# Access Compliance Report

## Public Rights-of-Way

### (Curb Ramps)

Intersection ID: 10026324	Main Street: FAIRVIEW_RD	Cross Street: N/A	Location: SE
ADA ID: 93098896E306	Ramp Type: PerpDiag	Initial Pass/Fail: Fail	Overall Compliance: No
			Severity Score: 33.75

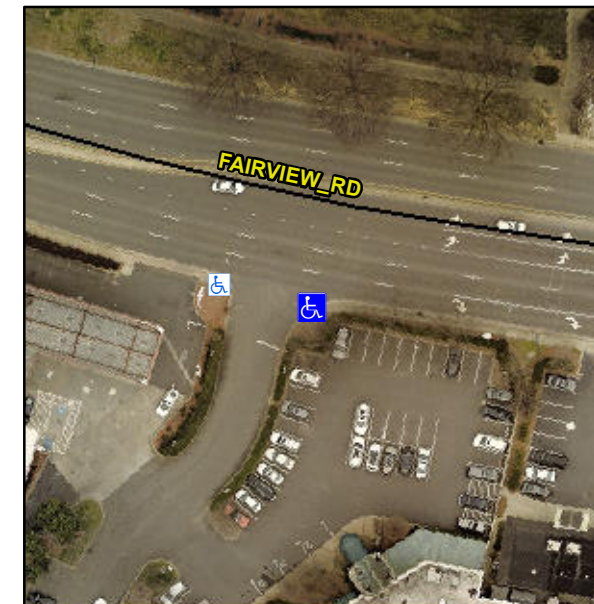
**Not Found, R304.5.1, R304.2.2**

Compliance	Description	Data	Compliance	Description	Data
N/A	Ramp Length (in)	46.0	No	Ramp Slope (%)	13.3
No	Ramp Width (in)	36.0	Yes	Ramp XSlope (%)	0.6
N/A	Flare Type LT	N/A	N/A	Flare Type RT	N/A
N/A	Flare Slope LT (%)	N/A	N/A	Flare Slope RT (%)	N/A
N/A	Flare Traversable LT?	N/A	N/A	Flare Traversable RT?	N/A
N/A	Landing Length (in)	N/A	N/A	DWS Provided?	N/A
N/A	Landing Width (in)	N/A	N/A	DWS Contrast?	N/A
N/A	Landing Slope (%)	N/A	N/A	DWS Length (in)	N/A
N/A	Landing X Slope (%)	N/A	N/A	DWS Full Width?	N/A
N/A	Landing Curb? (Y/N)	N/A	N/A	DWS Offset (in)	N/A
N/A	Shared Landing?	N/A			
N/A	Gutter Ponding?	N/A	N/A	Gutter Slope (%)	N/A
N/A	Gutter Lip Ht (in)	N/A	N/A	Gutter X Slope (%)	N/A
N/A	Painted X Walk1?	No	N/A	Painted X Walk2?	No
	X Walk 1 Direction	To NE		X Walk 2 Direction	To NW
N/A	X Walk 1 Width (in)	N/A	N/A	X Walk 2 Width (in)	N/A
	X Walk 1 Slope (%)	0.9		X Walk 2 Slope (%)	0.4
	X Walk 1 X Slope (%)	0.9		X Walk 2 X Slope (%)	2.5

**Remove & Replace Curb Ramp With Two New Directional Ramps or Equivalent.**
